NP-11-0001
January 11, 2011

Subject: Exelon Nuclear Texas Holdings, LLC
Victoria County Station Early Site Permit Application
Response to Request for Additional Information Letter No. 02
NRC-Docket No. 52-042

Attached are responses to NRC staff questions included in Request for Additional Information (RAI) Letter No. 02, dated December 17, 2010, related to Early Site Permit Application (ESPA), Part 2, Sections 2.3.3, 2.3.4, and 2.3.5. This submittal includes responses to the following Questions:

Figure 1: Sensitive Receptor Locations

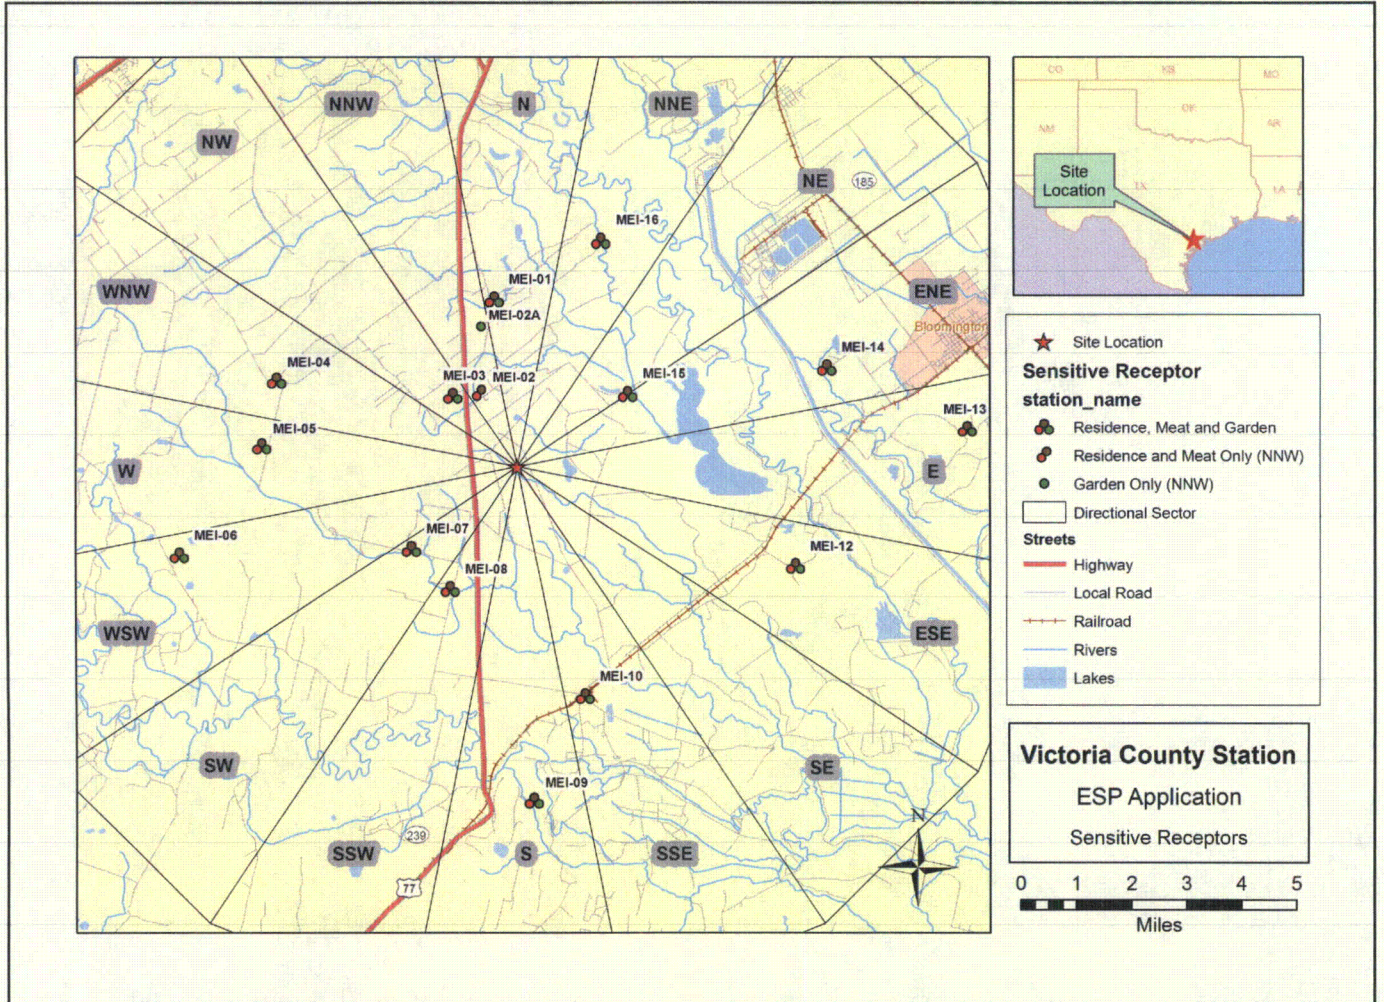
The staff was unable to determine the basis for the receptor locations near the VCS site. In order for the staff to complete an independent review of the long-term dispersion atmospheric estimates, this information is needed. Please provide the basis for the source receptors discussed in SSAR Section 2.3.5 and the distances provided in SSAR Table 2.3.5-1.

The locations of the receptors used in the XOQDOQ analysis are based on the shortest distance from the power block area boundary to the closest residence, vegetable garden, or meat animal for each directional sector. The identification of each receptor was accomplished through the use of satellite imagery and field reconnaissance as follows:

- Using satellite imagery, all nearest potential residences, gardens, and meat animals in each directional sector closest to the proposed power block were first identified.
- Field reconnaissance was subsequently performed to verify each identified receptor.
 - The field reconnaissance work consisted of driving all access roads to confirm the locations determined by satellite imagery.
 - Land owners were also interviewed for any additional information regarding potential receptor locations that were not identified during the satellite imagery investigation.
 - Each of the confirmed sensitive receptors were cataloged during field reconnaissance work with a hand-held GPS unit.

Table 1 summarizes the distances from the power block to each receptor for every directional sector. Figure 1 illustrates the locations of the receptors for each directional sector surrounding the VCS site.
